**UNITED STATES
NUCLEAR REGULATORY COMMISSION**
REGION III
2443 WARRENVILLE ROAD, SUITE 210
LISLE, IL 60532-4352

EA-11-243

**SUBJECT: PALISADES NUCLEAR PLANT - NRC SPECIAL INSPECTION TEAM (SIT)
REPORT 05000255/2011014 PRELIMINARY YELLOW FINDING**

FIGURE 2 - SIMPLIFIED DIAGRAM OF LEFT TRAIN 125-VOLT DC BUS DE-ENERGIZED DURING EVENT

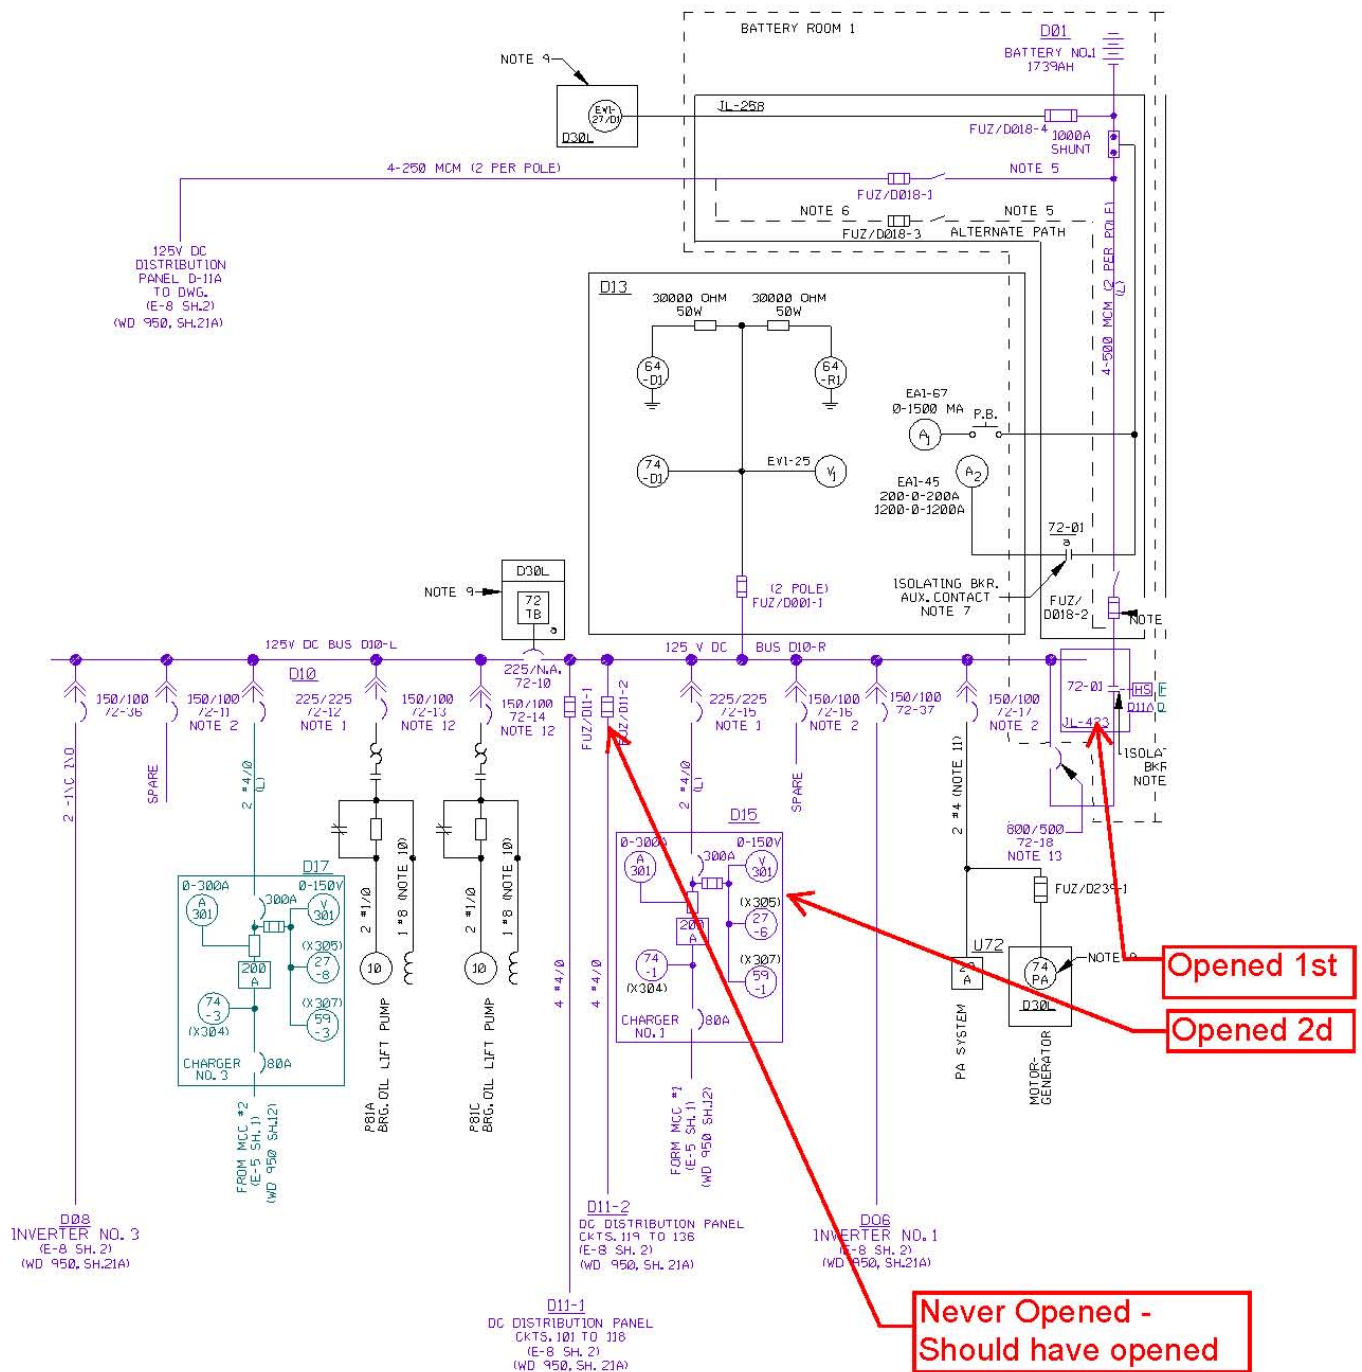
An electrical fault occurred from this contact between the positive and negative bus bars. This fault revealed a latent design deficiency of the installed shunt trip Breaker 72-01, in that, the installed breaker had thermal and instantaneous trip settings actuate due to the fault. The installed thermal and instantaneous trip settings on the shunt trip breaker were not listed as a characteristic of the breaker in the plant's updated final safety analysis report (UFSAR), drawings, or calculations. The design and licensing basis documentation described the shunt trip breakers as only a non-automatic, manually-operated breaker without any thermal or instantaneous protection devices. Per the system design, the transient, that occurred due to the electrical fault, should have only resulted in the loss of Panel D11-2, due to the actuation of fuse FUZ-D11-2 (which should have isolated the fault from the rest of the loads on the bus). However, because the shunt trip Breaker 72-01, which was installed in 1981 for both the left and right trains of 125-Volt DC busses, had thermal and instantaneous protection for overcurrent, the breaker tripped free on an overcurrent setting when the electrical fault on Panel D11-2 occurred and the entire left train 125-Volt DC bus was lost (reference Figure 2 of Attachment 4).

RFO21 During Refueling Outage 21, 10 breakers were replaced by maintenance personnel inside electrical Panel D11-2, associated with the left train 125-Volt DC system (reference Figure 2, Attachment 4).

15:06 Electrical fault on Panel D11-2 caused the shunt trip Breaker 72-01 to open (reference Figure 2 of Attachment 4).

FIGURE 4 - DC DISTRIBUTION PANEL D11-2 WITH BREAKERS 72-119 AND 72-120 REMOVED

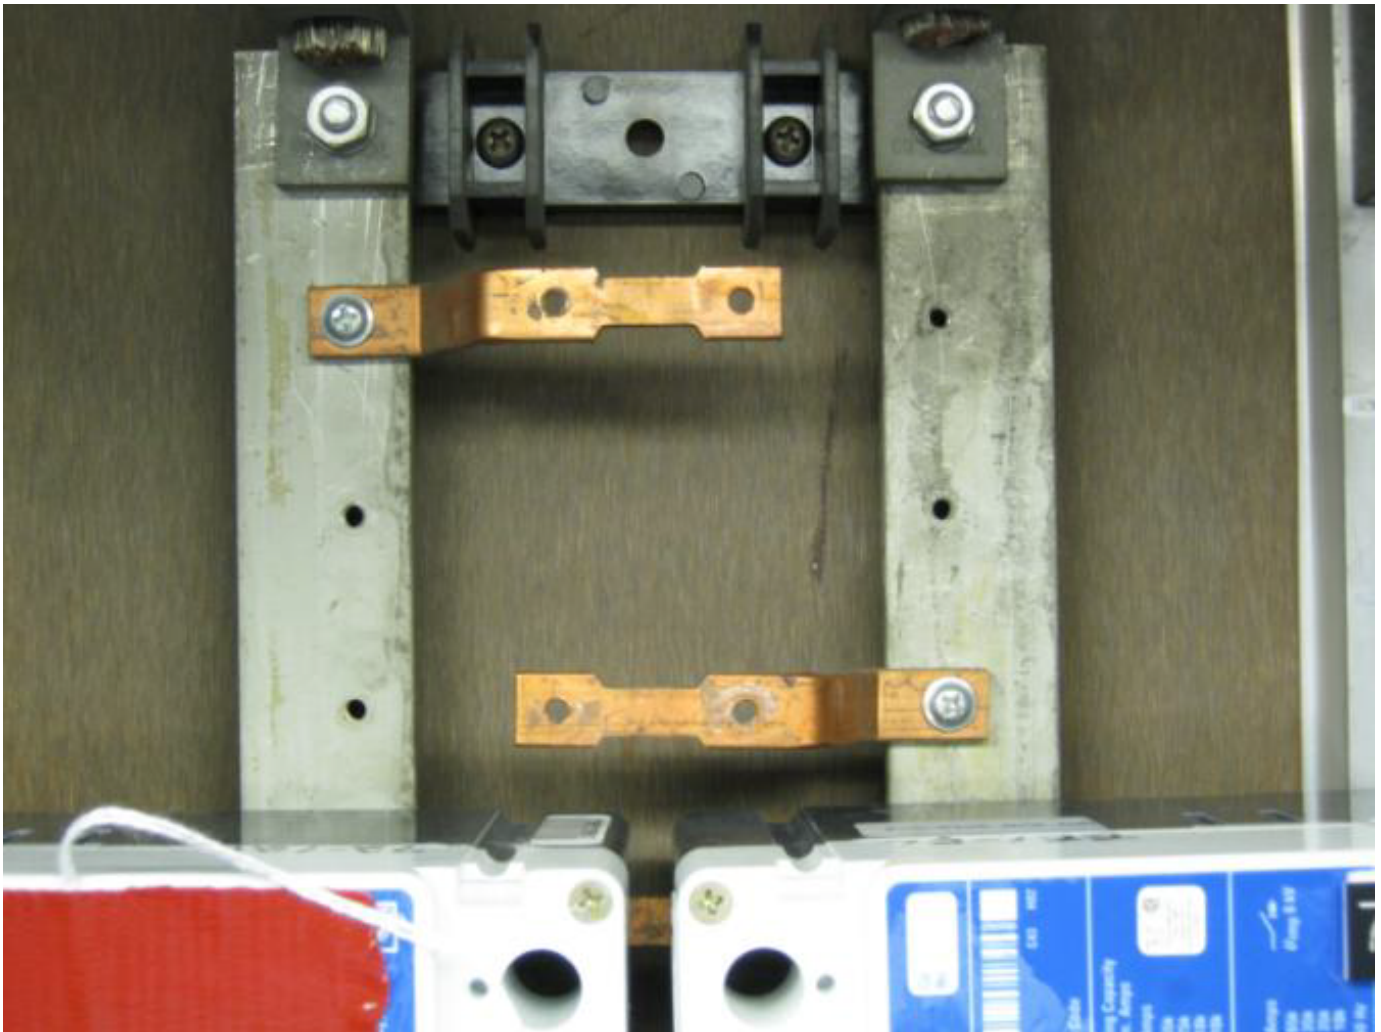
Following the removal of the fourth breaker and after the observers inspected Panel D11-2, the electricians began removal of the first positive horizontal bus stab located in the upper left-hand corner of the bus (reference Figure 4 in Attachment 5). The workers were concerned that the single screw holding the horizontal bus stab would fall into the bus cubicle, so they devised a plan to hold onto the horizontal bus stab with one hand, loosen the screw with the other hand, and slowly back out the screw. At the time, the workers believed they met the intent of a note in the WO package to insulate the bus stab because the electrician performing the work was wearing insulated gloves. The electrician felt positive control was maintained by holding the bus bar.

(Note that with both breakers removed the positive horizontal bus bar (top left copper stab) and the negative horizontal bus bar (right copper stab) were not insulated.)

**FIGURE 5 - DC DISTRIBUTION PANEL D11-2 WITH BREAKERS 72-119, 72-120
AND 72-121 REMOVED**

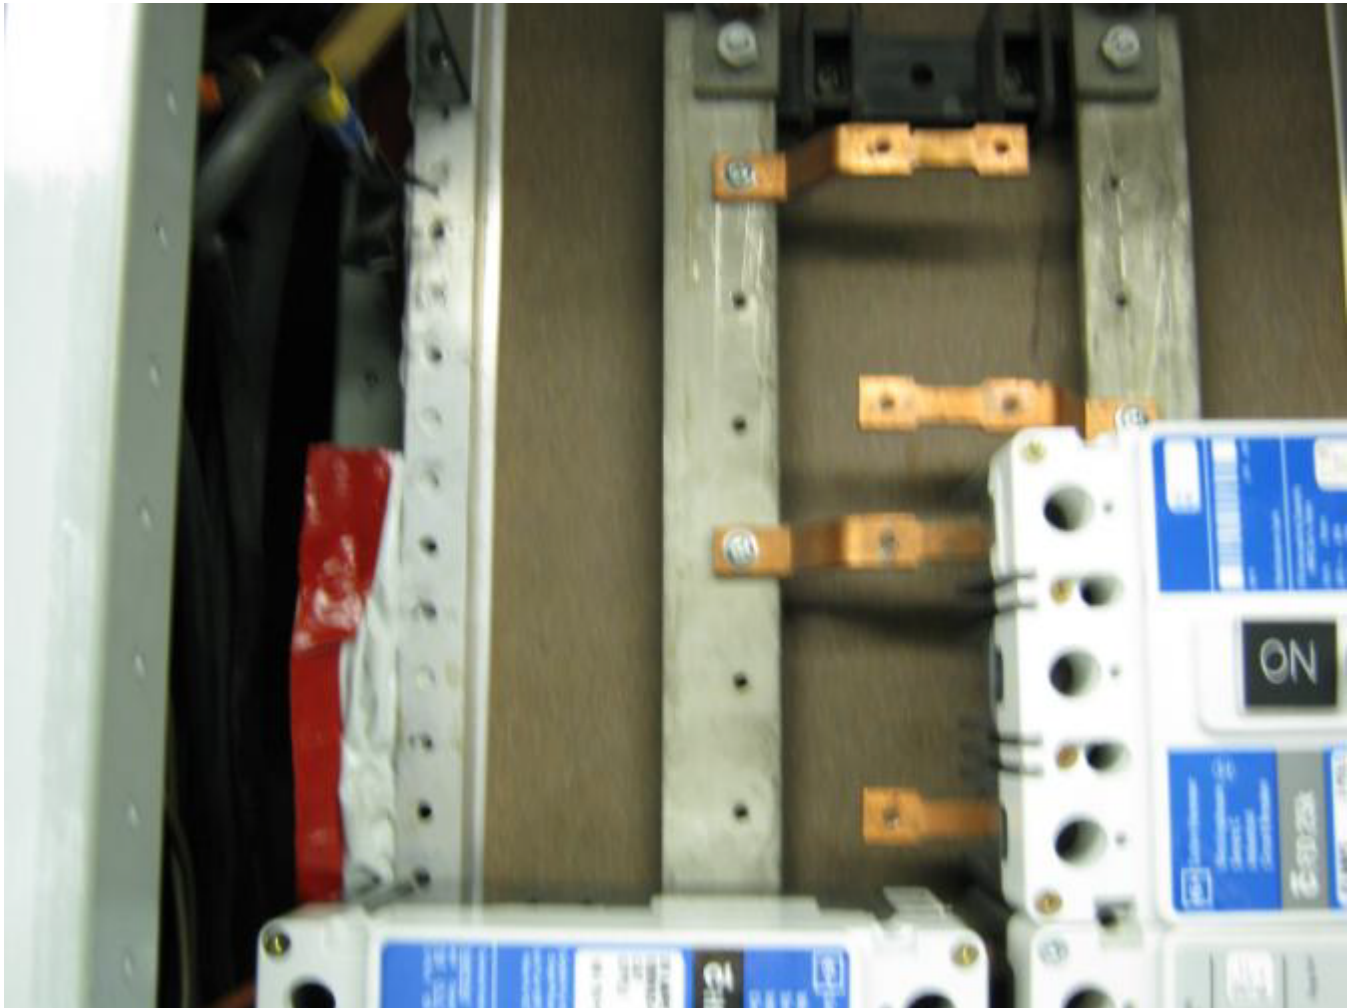
(Note that with three breakers removed the positive horizontal bus bar (top left copper stab) and the negative horizontal bus bar (upper right copper stab) were not insulated.)

FIGURE 7 - DC DISTRIBUTION PANEL D11-2 IMMEDIATELY FOLLOWING THE ELECTRICAL FAULT

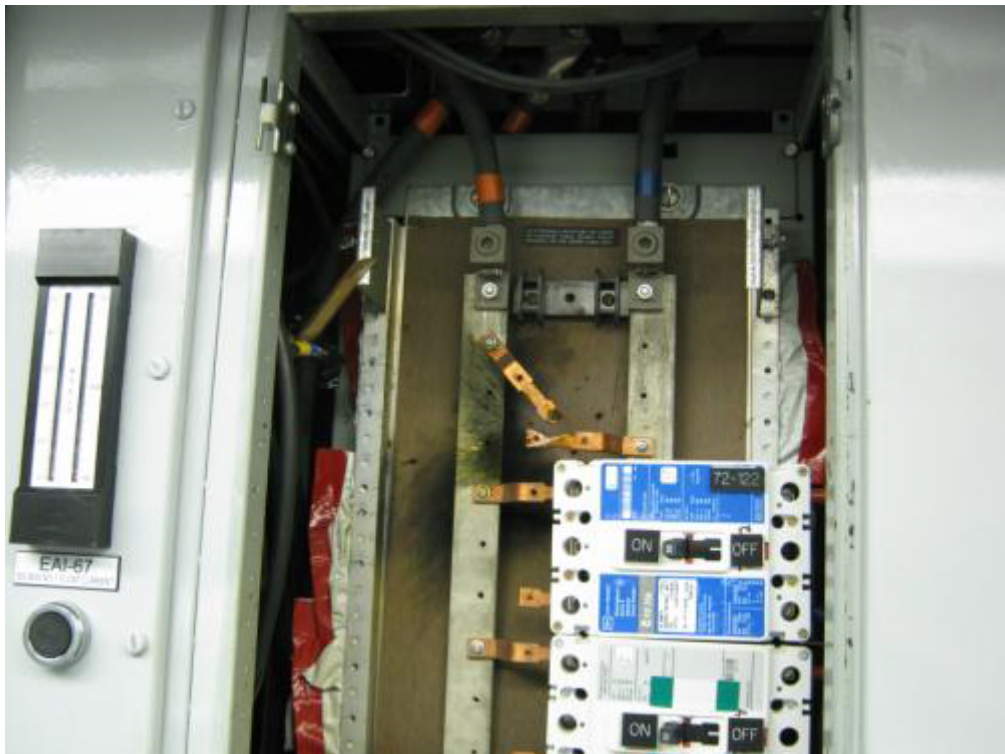
During the work, a horizontal bus bar slipped out of an electricians hand, causing an electrical fault on the left train of DC power distribution (reference Figure 7 in Attachment 5 of this report). Each train was comprised of a set of batteries, two chargers, instrumentation, and two inverters (reference Figure 1 in Attachment 4 of this report). The inverters provided AC power to the preferred AC busses, which in turn provided power to approximately 50 percent of the control room indications and controls.

At approximately 3:06 p.m. on September 25, 2011, after initially loosening the screw for the horizontal bus bar, the worker saw a flash from the area of the cap of the screw after the break-away torque was reached. Upon seeing a flash, the worker's hands instinctively recoiled from the work area to protect himself, thereby letting go of the horizontal positive bus bar. The horizontal positive bus bar was loosened enough such that it rotated downward and contacted the negative bus bar causing a significant arc and melting of the bus bars as seen in Figure 7 of Attachment 5. The worker was not

(Note that when the positive bus bar, top left copper stab, was loosened and the electrician let go of it, the bus bar rotated down contacting the negative bus bar, which initiated the electrical fault on the left train 125-Volt DC system.)
